Bulletin No	59	2018-01	Issued: 030518	Revised:	Page 1 of 1
Equipment	PAIL DENESTER				
Topic	Separator Tooling Upgrade

Older Tooling Angle Limitation

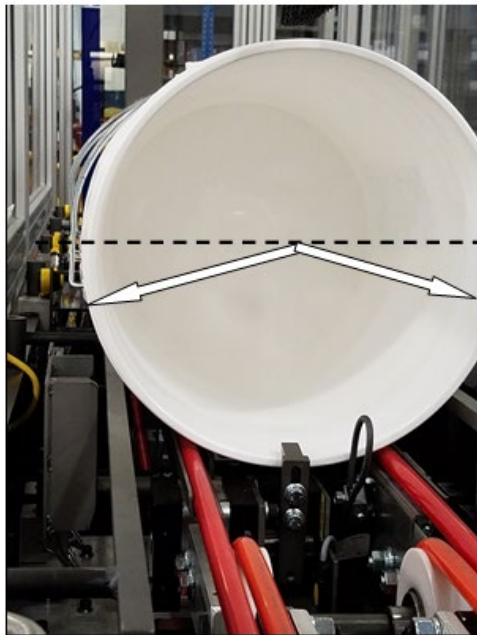
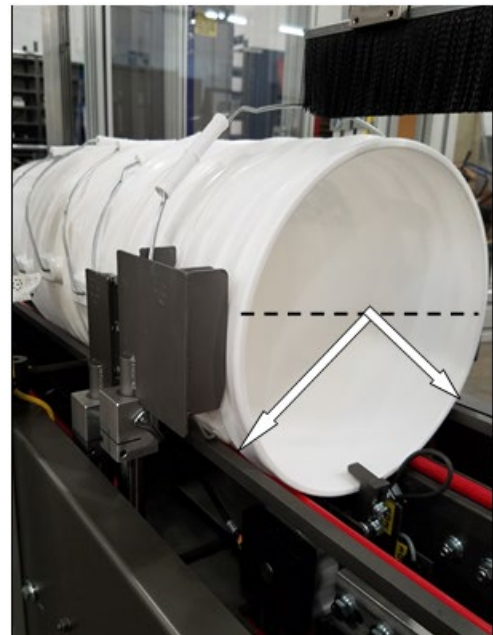
Older style Pail Denesters were limited to separating pails that had ears positioned no more than 15 degrees either side of level.

Approximately 15° to ear bottom.

The **Separator Tooling Upgrade** allows any of our Pail Denesters to separate pails with the ears positioned up to 35 degrees either side of level, while maintaining reliable handle lift.

Much greater separation angle with Upgraded Pulling Tooling

Approximately 35° to ear bottom.
Redesigned Pulling Tools and
Cylinder, offer higher handle lift.
